ENVIRONMENTAL REVIEW TEAM REPORT

BREEZY HILL
NEW HARTFORD AND CANTON, CONNECTICUT

AUGUST 1980

SIMPLIFIED SITE PLAN

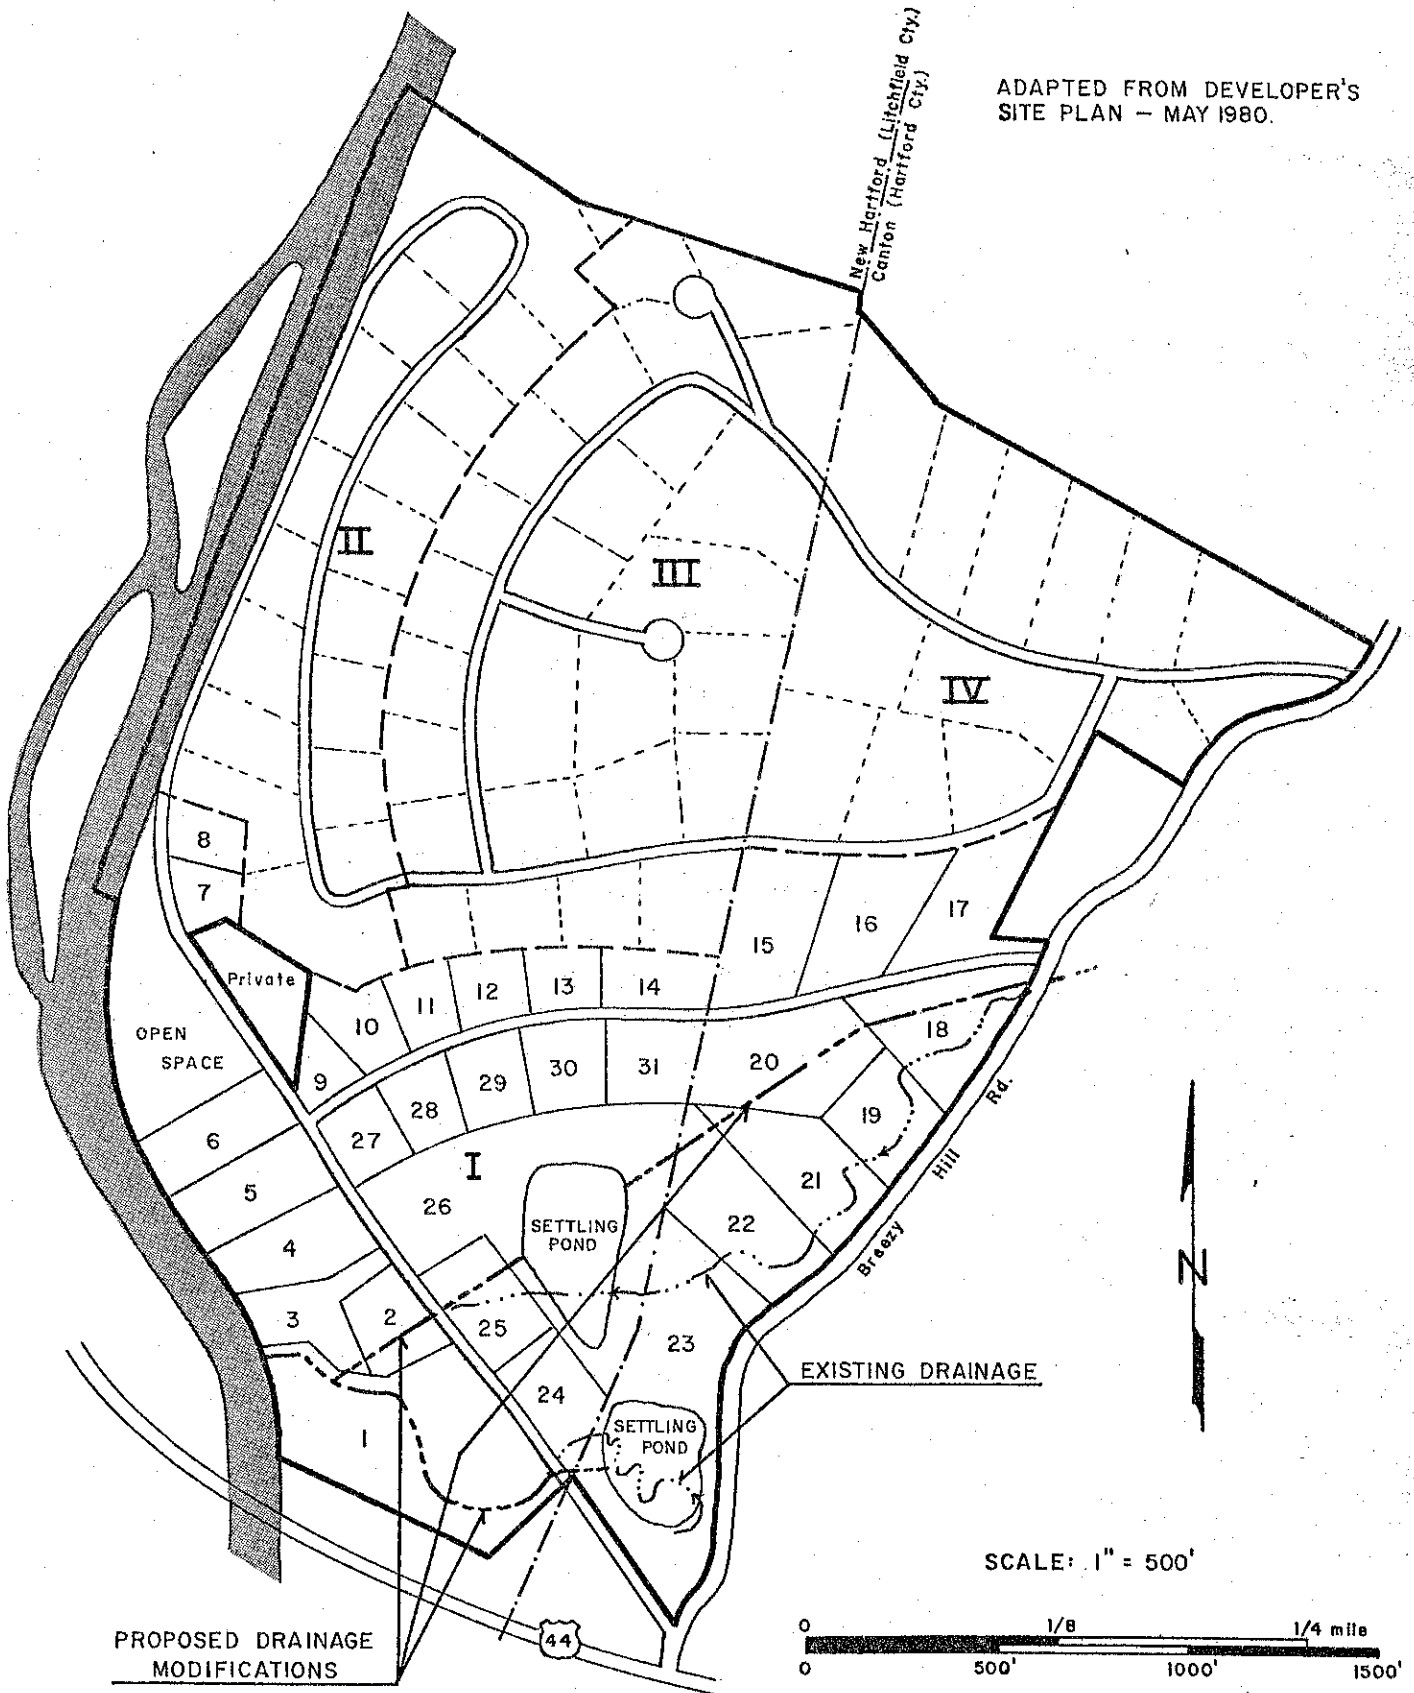
The developers have proposed the creation of two large sediment basins in the southeastern section of the property. One basin would intercept water diverted from the stream near Breezy Hill Road. The diversion would consist of a wide, terraced, artificial channel. The basin would be created by the removal of 150,000 cubic yards of gravel from the site. The other basin would be created by the removal of 50,000 cubic yards of gravel from the pond now existing in the southeastern corner of the site. Only a very small portion of the project site now flows into this pond. The basins theoretically are designed to collect sediment, but not specifically to mitigate peak flow increases, from fully developed watersheds. At present, both watersheds are only lightly developed.

Several considerations arise with respect to the proposed sedimentation basins. One is a policy consideration: should a developer of a subdivision design drainage facilities to accommodate not only the effects of his own subdivision, but also the effects of potential development upstream? If upstream development consistently took place a few lots at a time, making individual storm drainage systems impractical, the overdesign of the downstream facility would be crucial to maintaining the hydrologic status quo. However, in a project such as the Breezy Hill Subdivision, the upstream watershed of the major

A second consideration with regard to the proposed sediment basins is their lack of floodwater retention capacity. With an uncontrolled outflow during heavy storms, the basins will pass most of the peak flow increases from development downstream. If the basins are to be designed to accommodate increased sediment production for their entire watersheds once those watersheds are fully developed, they should be designed also to prevent peak flow increases for their entire watersheds. Otherwise, in order to control peak flows, upstream landowners would still have to develop their own drainage facilities, defeating one of the apparent objectives of overdesigning the downstream basins.

Officials of the Town of Canton expressed concern that the proposed new stream channel would "surcharge" the local water table, causing wetness problems in some lots. The sand and gravel underlying the proposed channel seems capable of rapid transmission of surface water to the water table, and would

Considering all of the factors listed above, it seems that the most practical solution with regard to this subdivision proposal would be to scale down the drainage plan and tailor it more to the needs of this site and less to hypothetical future needs arising from upstream development. In view of the minimal peak flow changes that the Breezy Hill subdivision itself would cause, the extensive rechanneling is not necessary. Provision could be made for a much smaller sediment basin with a controlled outlet to prevent peak flow increases. Perhaps a small channel from the existing stream near lot 23 could be extended to the existing pond to direct exceptionally heavy flows to that pond (there appears to be a great deal of storage space available in the pond). The bed elevation of the new channel could be calculated on the basis of the estimated level of the present stream during a 10 year or 25 year storm. Other ideas may suggest themselves to the developers, but the present plan seems needlessly ambitious and may produce more of an environmental disruption than a benefit.

SURFICIAL GEOLOGY (INTERPRETED
BY M.A. ZIZKA, JULY 1980, FROM FIELD OBSERVATIONS
AND SCS SOILS MAPS.)

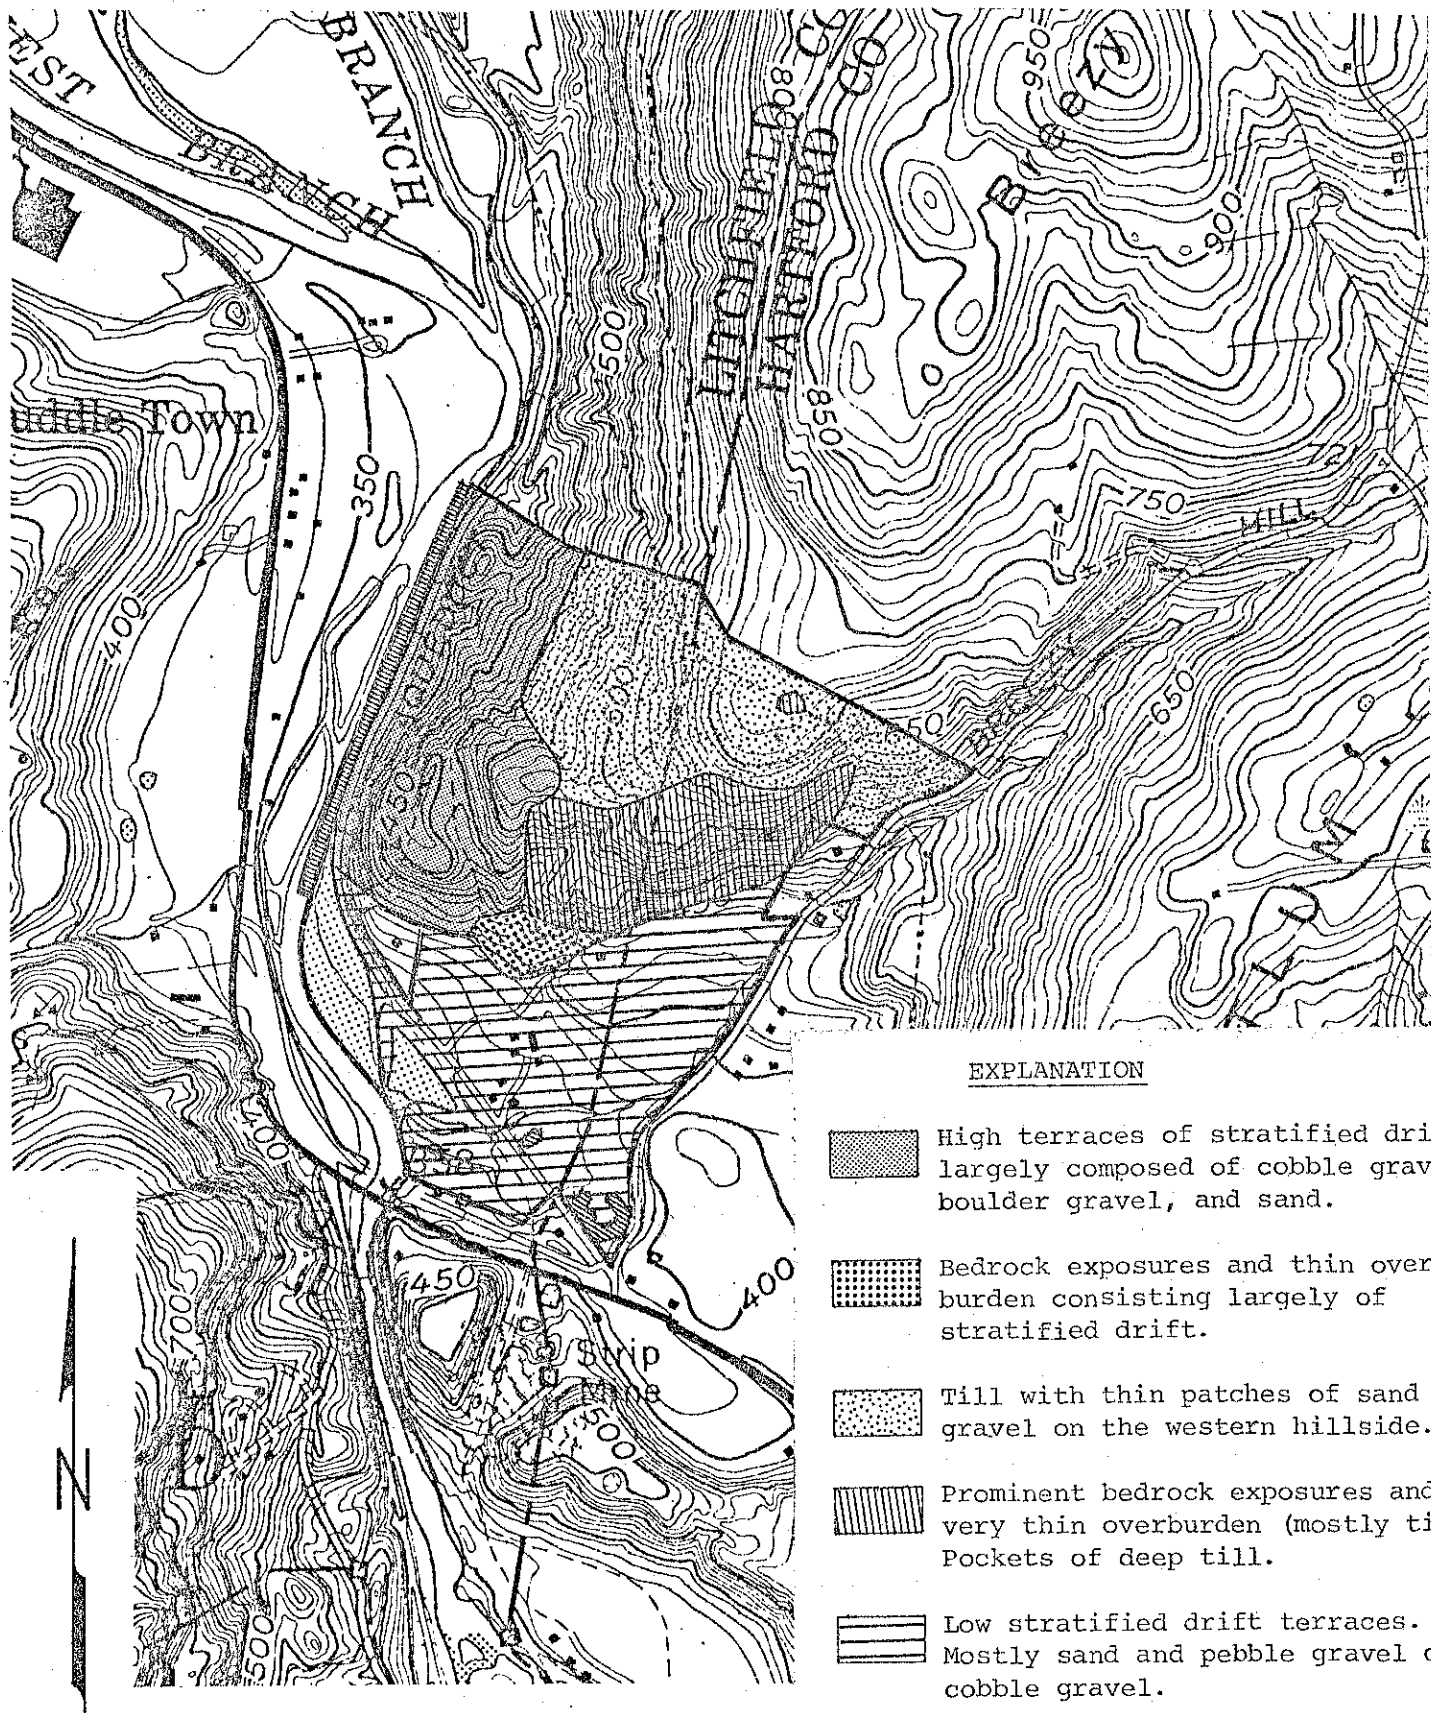
The surficial geology of the site is difficult to interpret. Colton's preliminary map and the Soil Conservation Service's soils map differ as to the extent of the sandy and gravelly deposits (stratified drift) on the site. Colton's map restricts the deposits to the gently and moderately sloping areas below the 450 foot elevation contour in the southern portion of the property (approximately the area designated as Section I on the subdivision plan) and the knoll in the northwestern corner of the site. The soils maps, on the other hand, indicate that the stratified drift extends uphill from the west as far as the 600 foot elevation contour. Time constraints prevented the Team from resolving the inconsistencies, but the field review on July 2, 1980 and a subsequent walk of the site by the Team geologist indicated that the soils map offers the better interpretation.

Figure 4 shows the Team geologist's interpretation of the surficial geology of the site. The landowner and town officials should be aware, however, that the sediments may be more complex than Figure 4 indicates. Individual on-site testing would definitely be necessary in evaluating the potential of the lots planned for Sections II, III and IV.

FIGURE 5
SITE PLAN AND SOIL TYPES

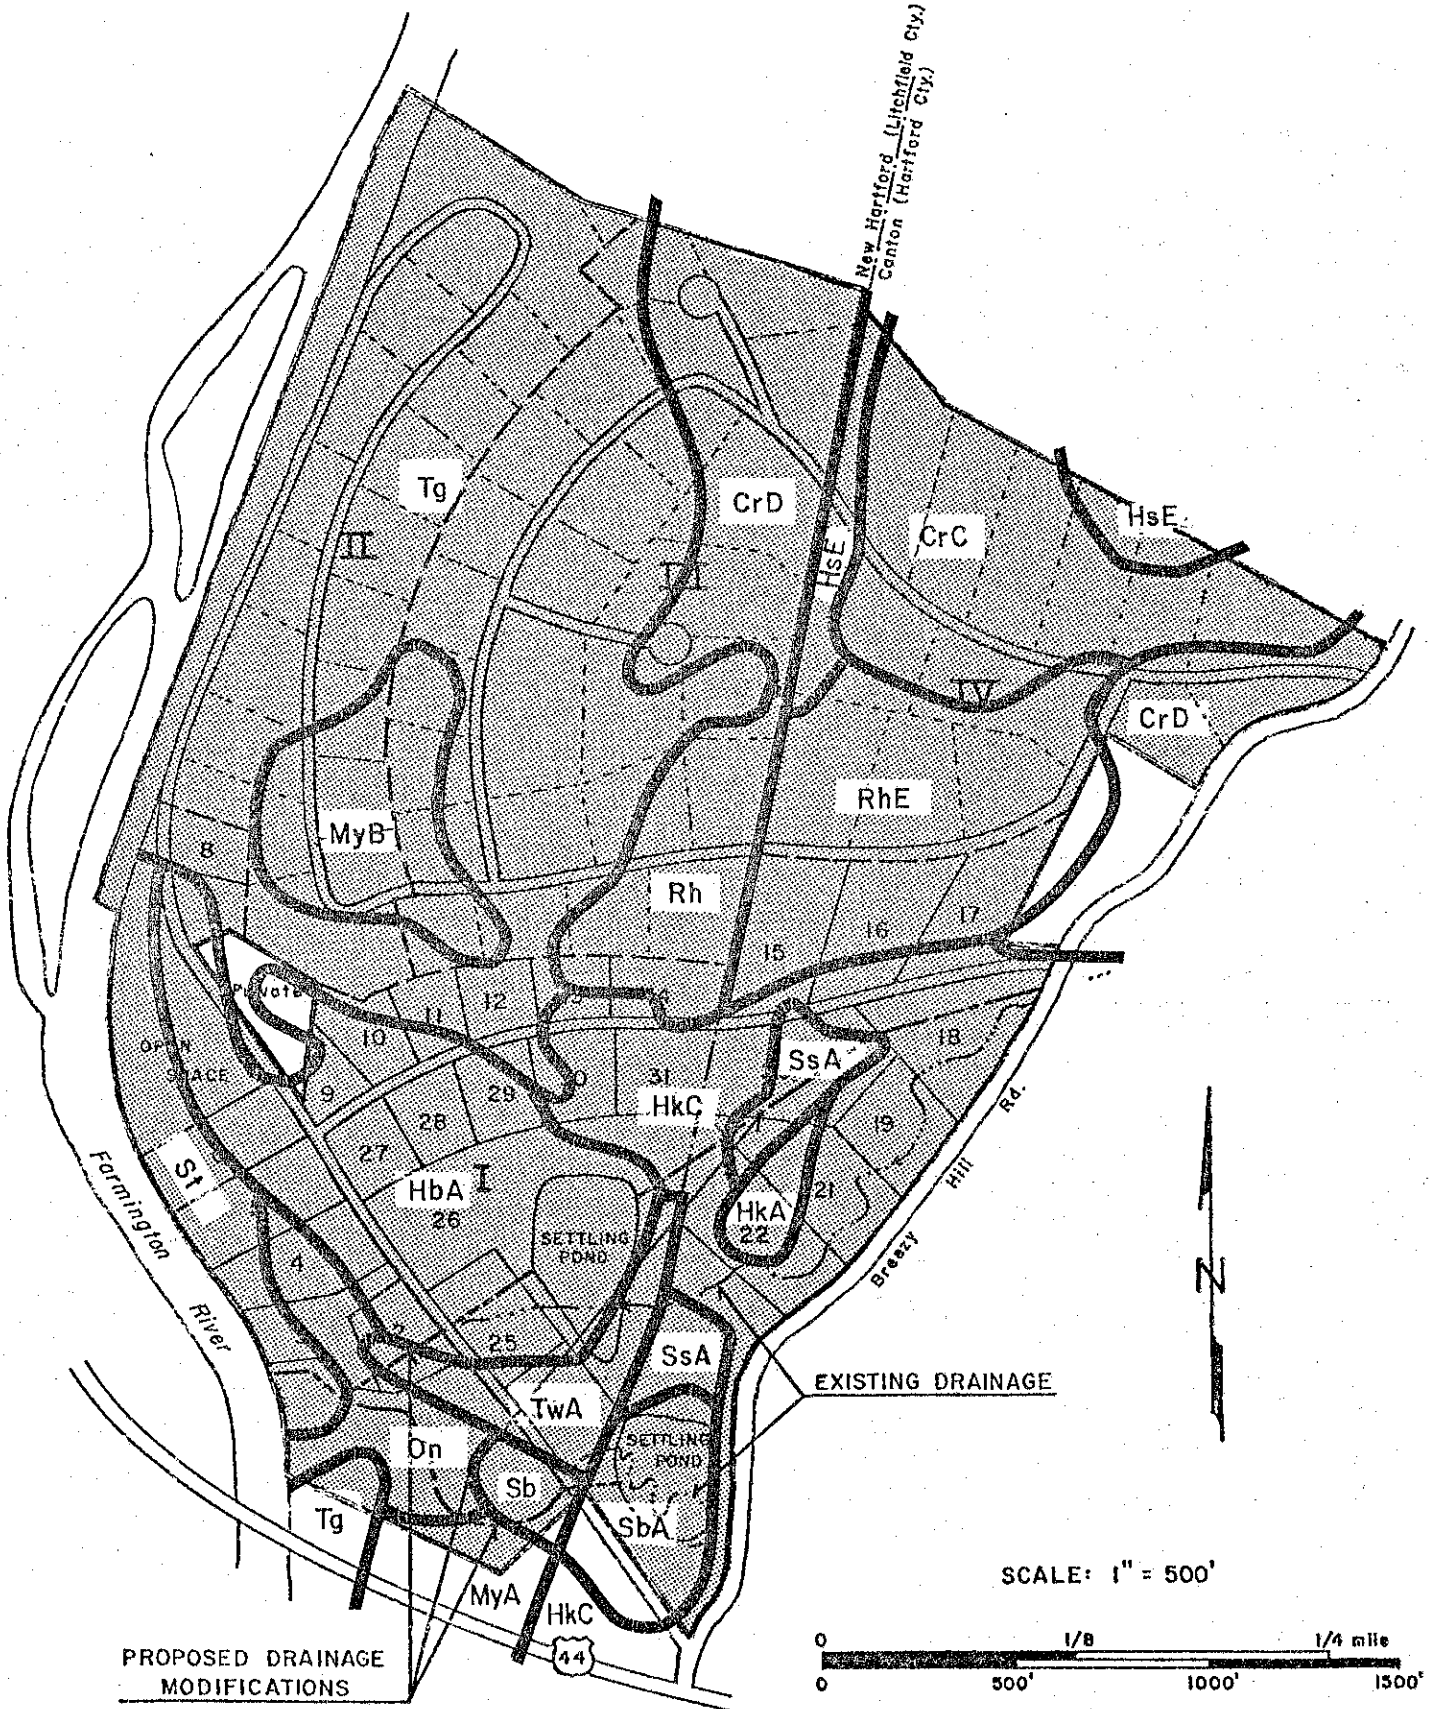
For On-Site Sewage Disposal - This soil has a moderate limitation due to poor renovation potential and filtration capacity of sandy substrata. This soil may be associated with high yielding groundwater supplies. Therefore, sewage effluent may pollute groundwater. Management Practices to overcome soil limitations are: restricted percolation testing; large field, sand filter or mound systems; enlarge leaching area; and avoid construction when wet.

For On-Site Sewage Disposal - This soil has a severe limitation. It is underlain at about 2 feet by water deposited, stratified layers of sand and gravel. This soil also may be associated with high yielding groundwater supplies. Poor filtration of sewage effluent occurs due to the low clay content and high sand and gravel content of the soil. There is hence a hazard of groundwater contamination. Management practices to overcome soil limitations are: control of housing density; sewage collection; and on slopes of 3-15%, serial tile distribution. For Landscaping This soil has a moderate limitation. Land grading exposes underlying sand and gravel which is excessively drained and low in natural fertility. Management practices, singly and/or in combination to overcome soil limitations are: addition of organic matter (peat, manure, mulched leaves, etc.); topsoiling; liming, fertilizing; using adaptable seed mixes/species; and irrigating.

For All Urban Uses - These soils have a severe limitation due to the hazard of flooding. Other Uses - Potential exists for recreation uses (picnicking, play areas), and the establishment, improvement or maintenance of wildlife habitat. The Ondawa soil is considered "Prime Farmland", well suited to the production of grasses and legumes, silage corn and late vegetables.

For On-Site Sewage Disposal - This soil has a severe limitation due to a seasonal high water table. It also has a poor renovation and filtration capacity due to the sandy/gravelly substrata found at about 34 inches. Management practices to overcome soil limitations are: restricted percolation testing; regional drainage (such as with "curtain drains" or land fill); sewage collection; and control of housing density. For Homes with Basements - Measures such as footing drains are necessary to prevent seepage into basements. For Roads and Driveways - Subsurface drains are necessary to prevent problems of frost heaving and ice buildup from seepage and seasonal high water table.

For Proposed Urban Uses (homesites/roads) - These soils have severe limitations due to slopes primarily in excess of 25%. Disturbed areas are difficult to stabilize due to droughtiness and the low natural fertility of underlying sand and gravel.

For All Urban Uses - These soils have a severe limitation due to outcropping of rock covering more than 50% of the surface and in Phase I of this site, slopes are generally in excess of 25%. These soil areas serve a purpose in that they are picturesque and enhance adjoining areas.
